SANDIA REPORT

SAND2014-2647
Unlimited Release
Printed April 2014

Review of Inputs Provided to Jason Associates Corporation in Support of RWEV-REP-001, the *Analysis of Postclosure Groundwater Impacts* Report

Charles R. Bryan, Philippe F. Weck, Palmer Vaughn, Bill W. Arnold

Figure 1. Groundwater pumping estimates (in acre-feet) for the Amargosa Desert generated by the State of Nevada, Division of Water Resources between 1983 and 2012.

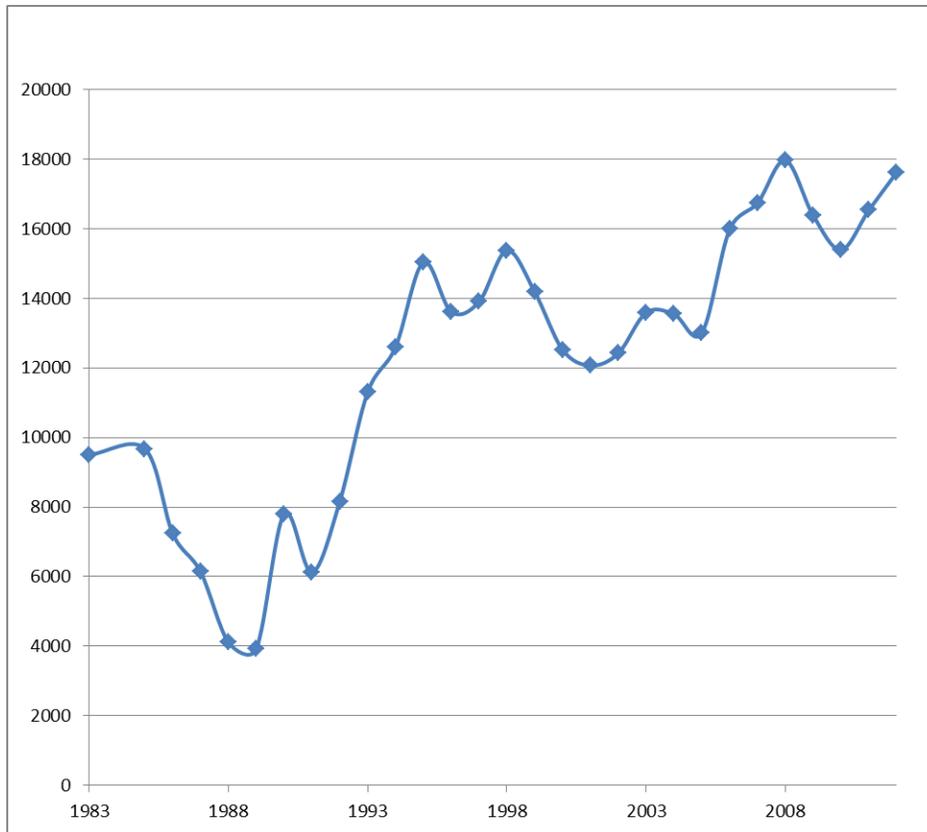
Significant changes in the pumping rates in the Amargosa Valley might have required rerunning the DVRFS, because in the “pumping” scenarios, these pumping rates are used. The pumping rates used in the 2009 report are based on 2003 data. As shown in Table 2-1 of the *Groundwater Impacts* report (DOE 2009a), groundwater pumping in 2003 consisted largely of irrigation-related pumping in the Amargosa River section of the Central Death Valley subregion (17,600 acre-feet), while the Fortymile Canyon section (92 acre-feet) and the Funeral Mountains section (55 acre-feet) represented only minor contributions (see Moreo and Justet 2008 [DIRS 185968], database) to the total. In the Southern Death Valley subregion, the only groundwater pumping activity in 2003 was in the Shoshone-Tecopa section (27 acre-feet, including pumpage from the California Valley section; see, Moreo and Justet 2008 [DIRS 185968], database).

The 2009 *Groundwater Impacts* report DVRFS calculations used total groundwater pumping rates for the Amargosa Valley of 14,100–21,200 acre-feet per year from 1994 to 2003, averaging 16,800 acre-feet per year. These data are based on USGS estimates of groundwater withdrawal in the Valley. While more recent estimates of pumping rates by the USGS have not been published, the State of Nevada, Division of Water Resources (NVDWR) has published additional data (see, Amargosa Valley No. 230, <http://water.nv.gov/data/pumpage/?basin=230>, last retrieved 3/10/2014); these data are shown in Figure 1. NVDWR estimates of groundwater withdrawal rates from 2006 to 2012 range from 15,400 to 18,000 acre-feet per year, averaging 16,700 acre-feet per year. This value closely matches the value used in the 2009 *Groundwater Impacts* report.

It is important to note that the USGS pumping estimates for the Amargosa Valley have in the past been slightly higher than the groundwater withdrawal rates calculated by the NVDWR, using the same USGS source data but a different approach for estimating irrigation rates in the absence of data (see RWEV-REP-001, p. 2-16). However, since the State of Nevada data constitute the only available data for the post-2003 period, they are appropriate for use to validate the range used in the 2009 report. On the basis of this comparison, there is no need to update the DVRFS modeling done in the *Groundwater Impacts* report to capture more recent pumping data.
